Landscape Rehabilitation

Final Design Report

Apache Junction Floodway & FRS
Apache Junction Outlet & Bulldog Floodway

**Final Review
Comments and Responses**

LOCATION MAP

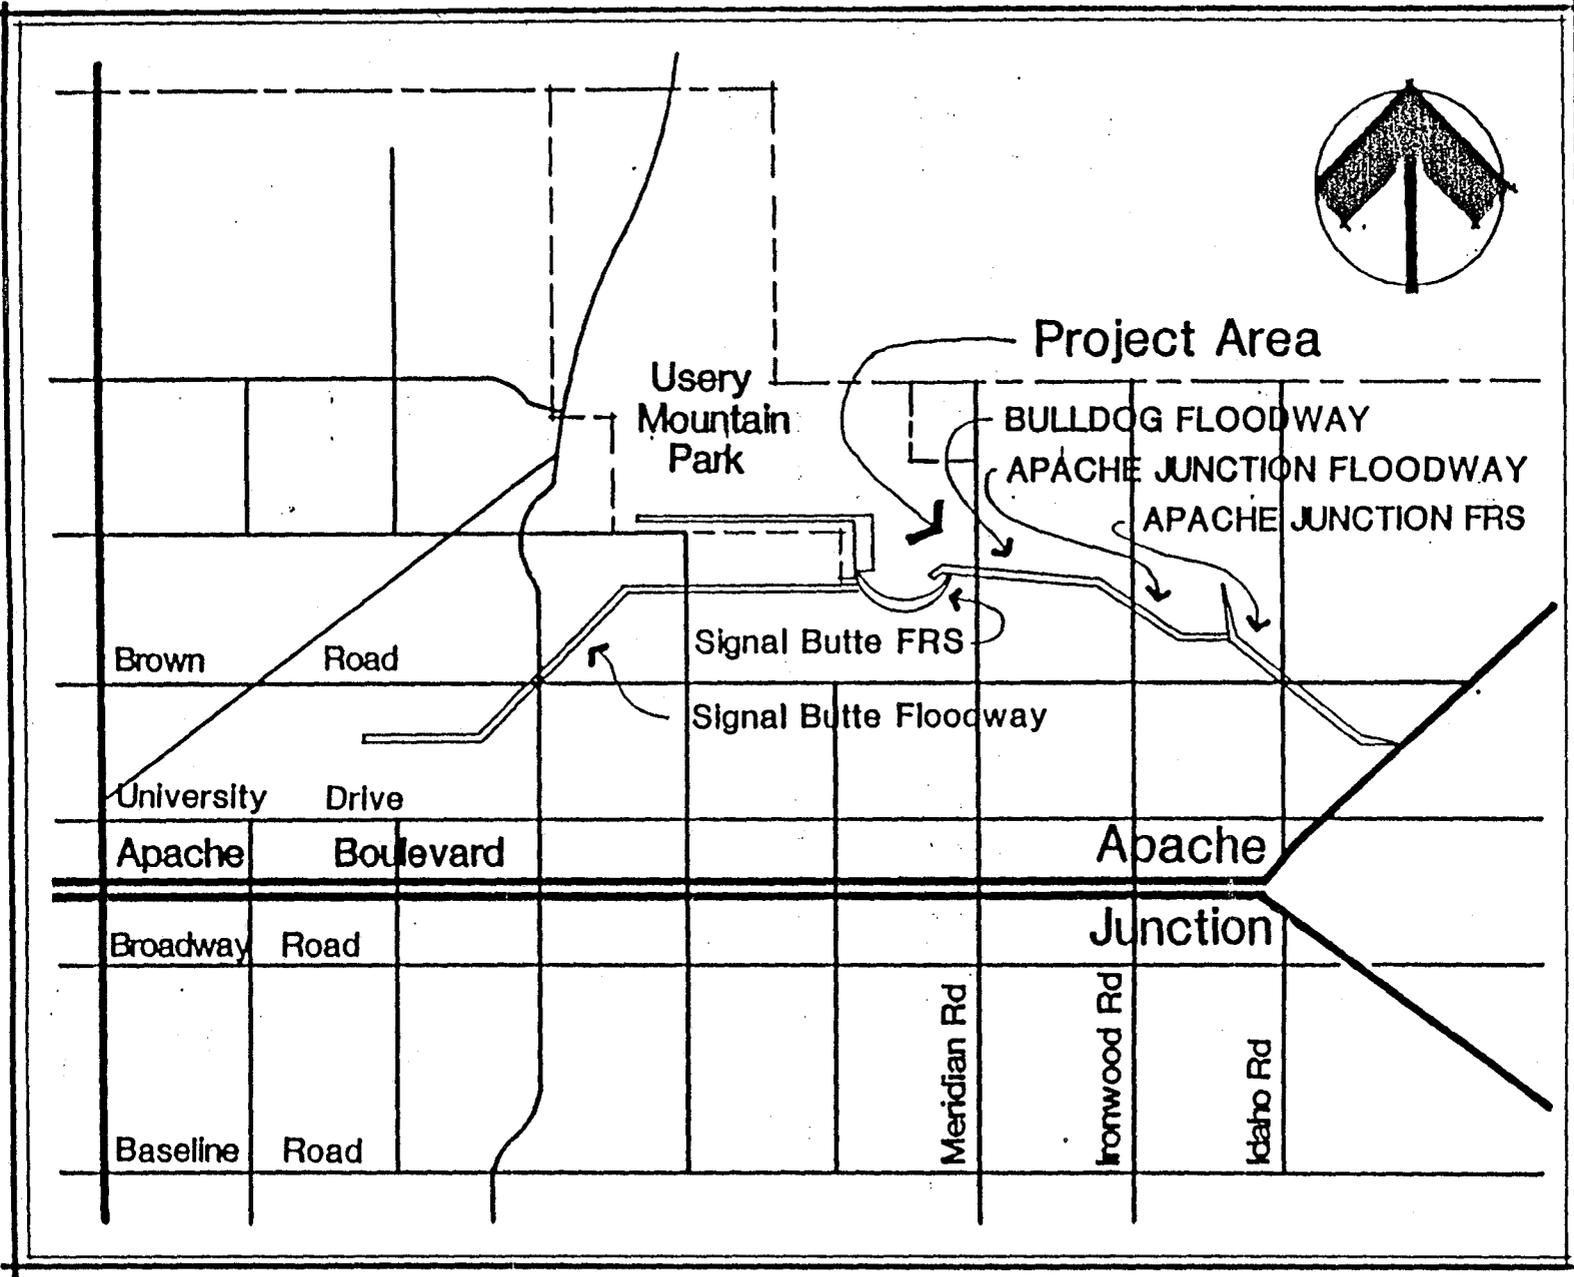
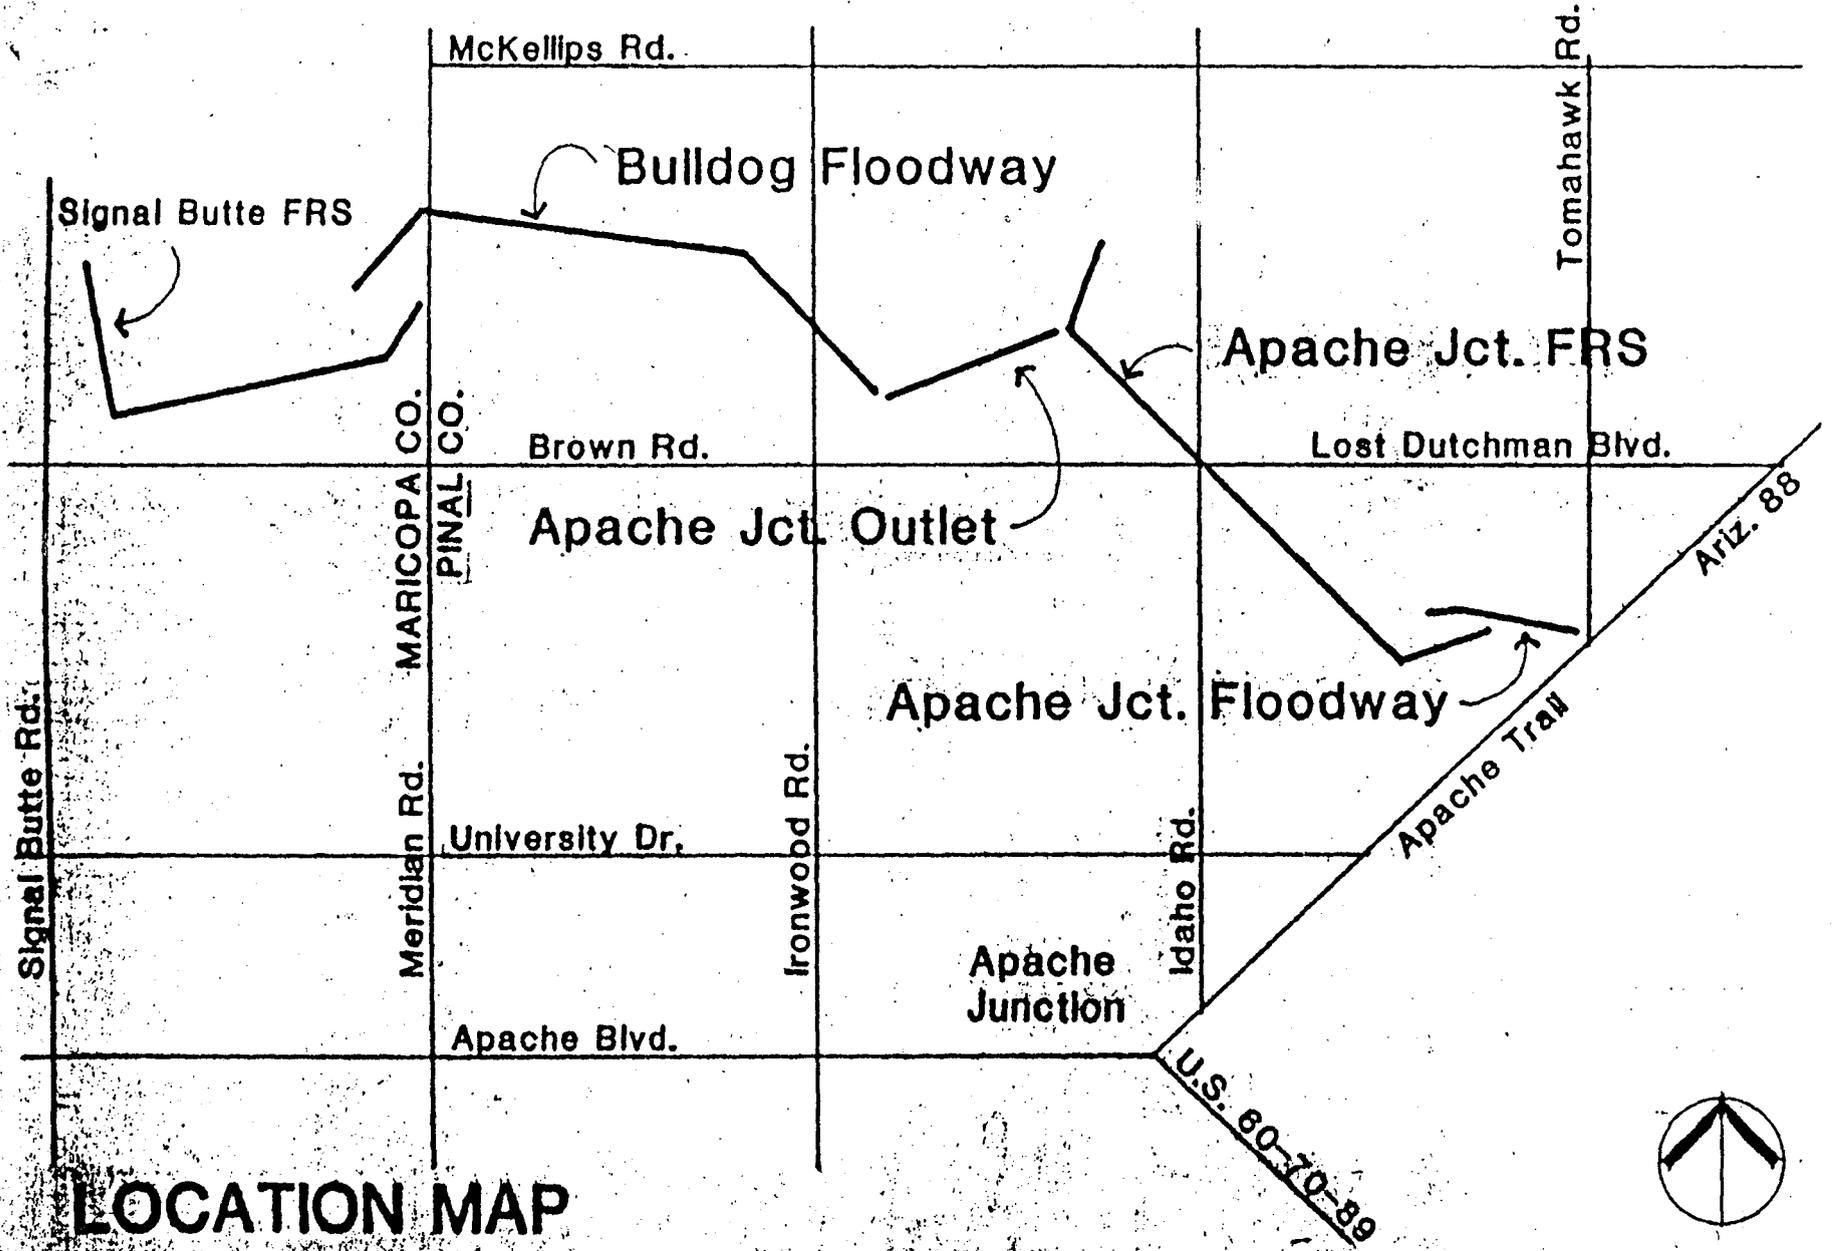
REMARKS: PER OUR DISCUSSION TODAY, I'LL USE "LOCATION MAP" FROM BLUEPRINTS AS CORRECT FOR STRUCTURE NAMES. RECOMMEND "LOCATION MAP", "FIGURE 1", P. 2, FROM LANDSCAPE REHABILITATION PRELIMINARY DESIGN REPORT BE CORRECTED / CLARIFIED, AS IT IS SOMEWHAT MISLEADING CURRENTLY. THANKS -

In working with the Landscape Rehabilitation Plans for the Apache Junction FRS, Floodway and Outlet, some confusion arose as to the correct application of the various structure names. The two location maps attached will serve to illustrate the problem. Which structure is Apache Junction Floodway? Please advise SCS and request clarification.

CM	KEB	2-26-87
FIRST MAP IS WRONG SEVERAL WAYS. SECOND MAP IS VERY GOOD AND HAS CORRECT NAMES, SAYS DON PAULLUS OF SCS. HAVE SENT WRITTEN REQUEST FOR FIRST MAP TO BE CLARIFIED. THANKS FOR IDENTIFYING!

ERRORS

1. The Location Map used on the plans has been included in the Final Design Report, and it replaces the one used in previous phases of the project.
